Model	SS930/950/915, Ges5130/5170/5210, Rex1060/1070/1140	Volt/Hz	Date of Modification	Serial Number
Modified Article	Upper Master Feed Roller & Upper Reverse Roller			
Reason for Modification	To increase the master paper feeding ability

DETAILS OF MODIFICATION

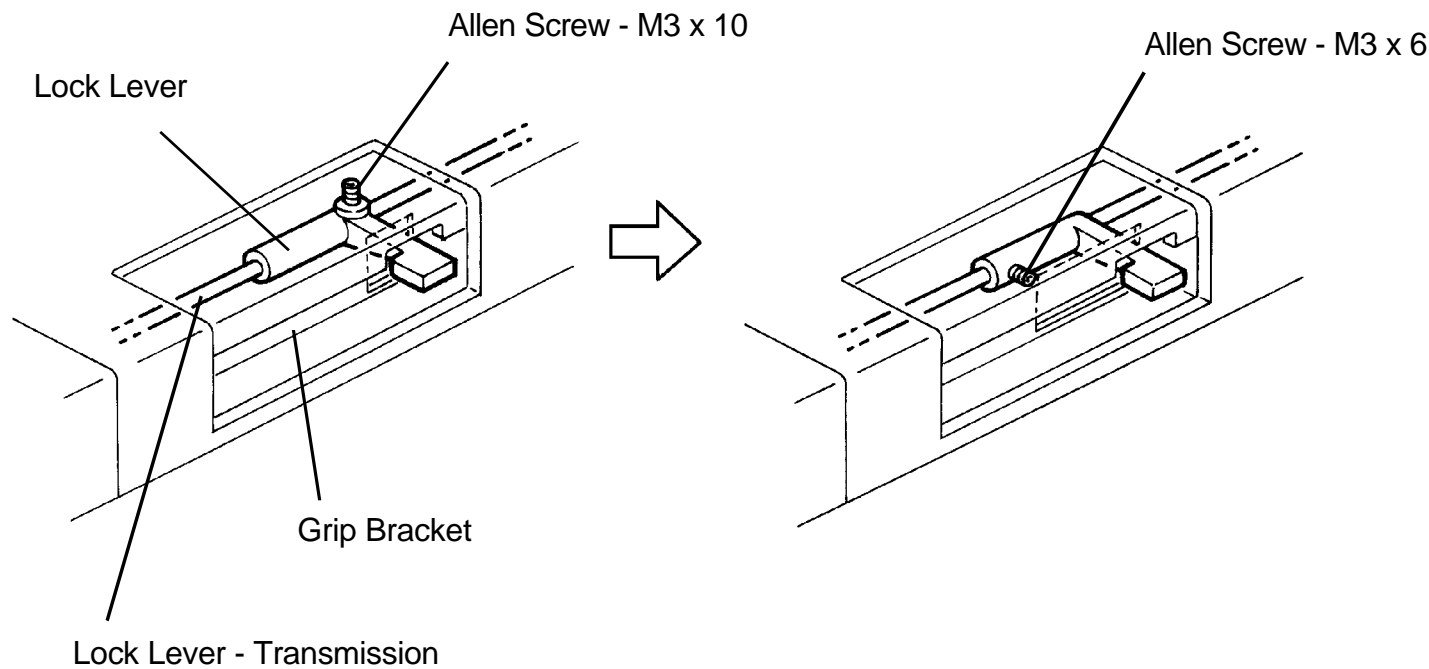
In the present machines, it is difficult to tighten the screw fixing the lock lever to the shaft. It is necessary to remove the scanner unit to access the screw.

To facilitate servicing, the direction of the screw has been changed and the cutout of the bracket has been enlarged so that a customer engineer can access the screw from the cutout of the bracket.

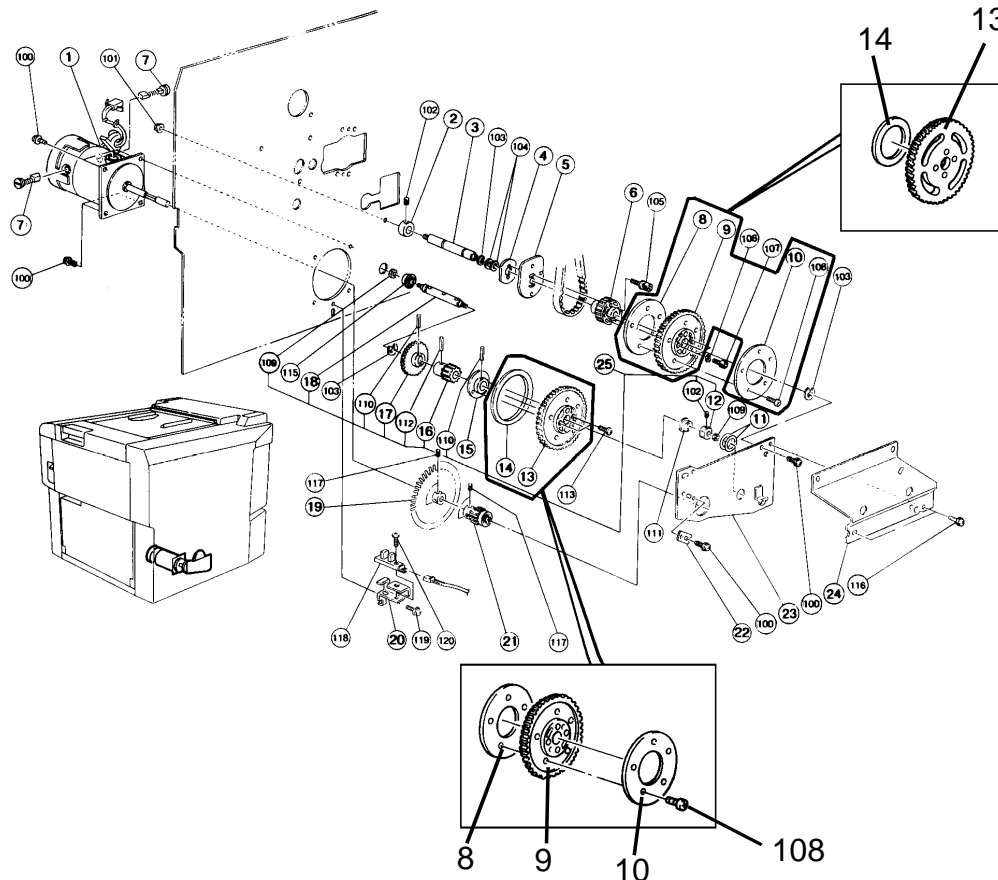
Please correct the illustration on page 9 as shown below.
